Remedial Action 95% Design Analysis Report

Beloit Corporation Superfund Site Rockton, Illinois

October 2007

Response to Illinois EPA and EPA Comments

Figure 3-9

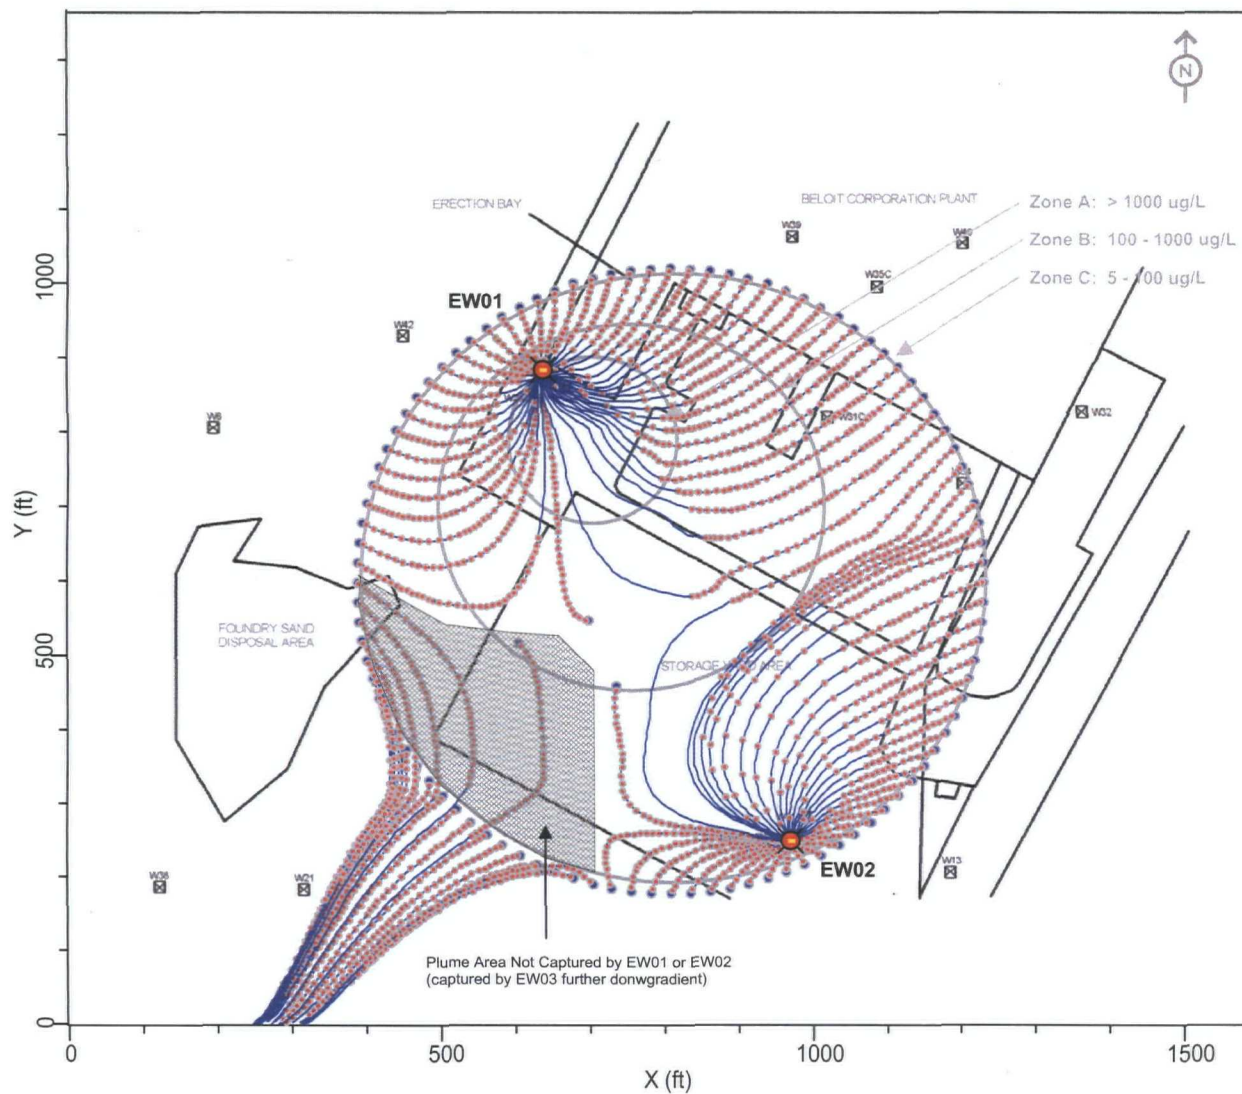
While the calibration appears acceptable, there are very few calibration targets. Figure 3-8 shows 5 monitoring wells that were not part of the calibration; why weren't they used? The few calibration targets is a significant source of uncertainty.
